SERVICE BULLETIN MAINTENANCE OF WAY EQUIPMENT

DATE: 06-2015 **BULLETIN NO:** 15-011

TITLE: JUPITER DIGITAL I/O MODULE FIELD POWER CIRCUIT BREAKER SIZE

PRODUCT SERIES / MODEL: WMATA UTV 354C (3 machines)

**FIGURE 1
CIRCUIT BREAKERS WIRING**

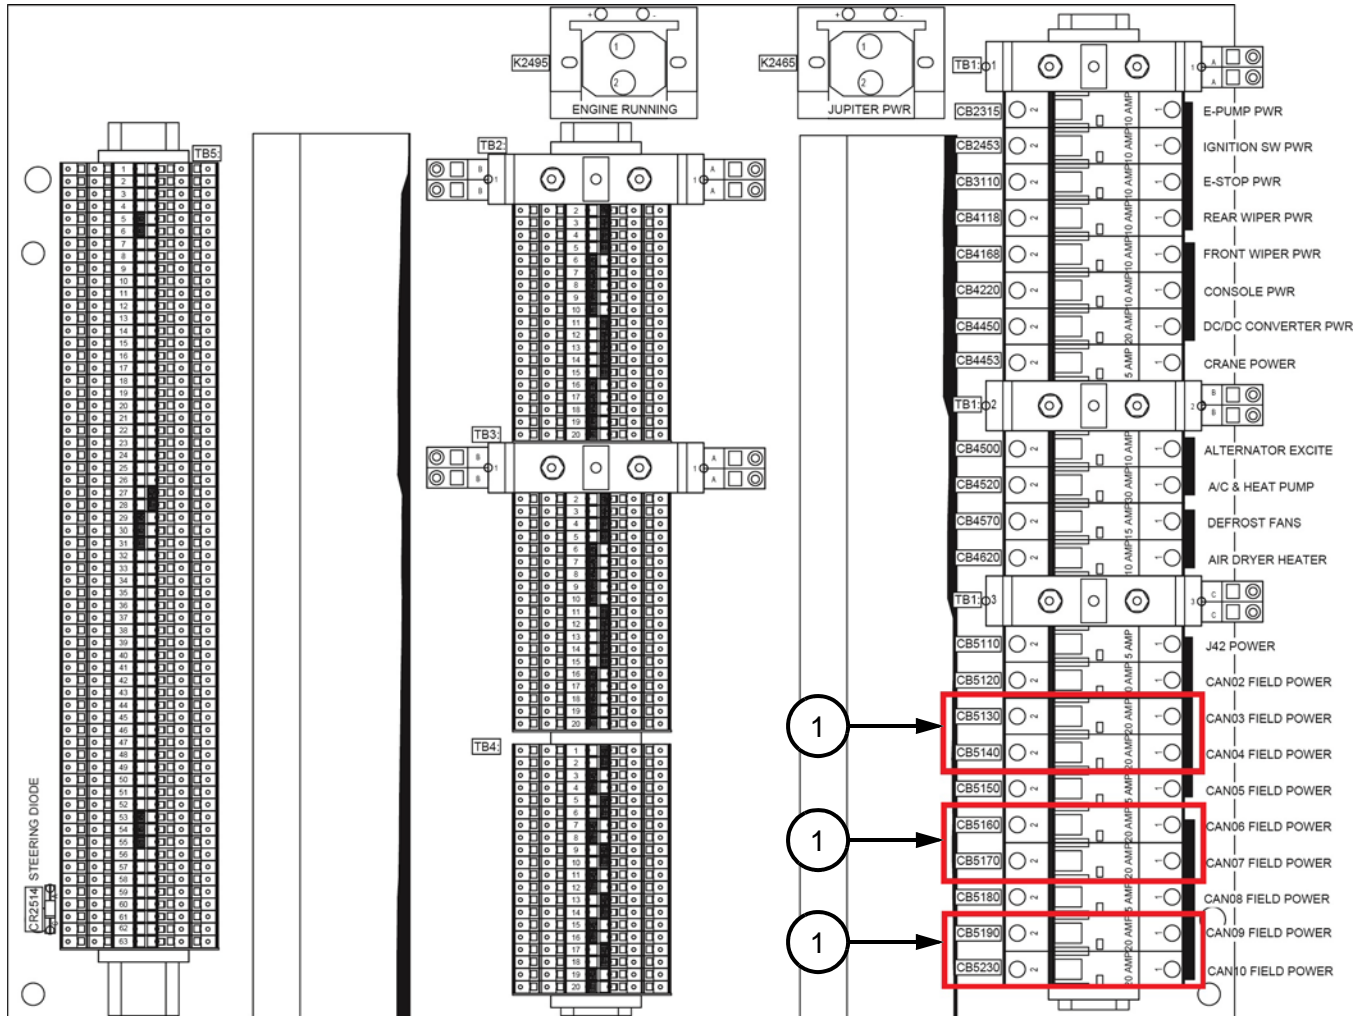
SUMMARY: A problem has been discovered with the size of some of the circuit breakers used on the Jupiter II digital I/O modules. Some of the Jupiter digital I/O modules are being protected with a 20 amp circuit breaker. As a result, the Jupiter field power cables and/or Jupiter module could over-heat and fail under certain operating conditions. A digital I/O module with two field power cables requires no more than a 15 amp circuit breaker. Harsco Rail recommends that the corrective actions be performed as soon as possible.

- 3. Find and replace the following 20 amp circuit breakers in the Main Console - CB5130, CB5140, CB5160, CB5170, CB5190, and CB5230. Follow the instructions below to replace the circuit breakers.

- 4. Circuit Breaker Removal: Disconnect the source wire from Pin 2 of the existing circuit breaker. Remove the buss bar from the existing circuit breaker if it is bussed to another circuit breaker. There is a retaining clip on the bottom side of the circuit breaker that needs to be pulled to remove the circuit breaker from the DIN rail.

OPERATIONAL IMPACT: Harsco Rail recommends replacing the 20 amp circuit breaker used on some digital I/O modules with an 15 amp circuit breaker (#5022143).

- 5. Circuit Breaker Installation: Install the new 15 amp circuit breaker (#5022143) on the DIN rail where the existing circuit breaker was located. Reconnect the source wire to Pin 2 of the new circuit breaker. If more circuit breakers need to be changed out that was fed by the buss bar, repeat Steps 4 and 5.
